Change in Ethernet Communication Connector Built Into the FX5UC CPU Modules

FAM-A-0050-A

Before change	After change

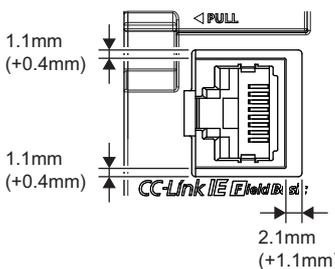
A built-in Ethernet communication connector will be changed as follows.

With this change, the dimension between the connector and connector opening will be changed.
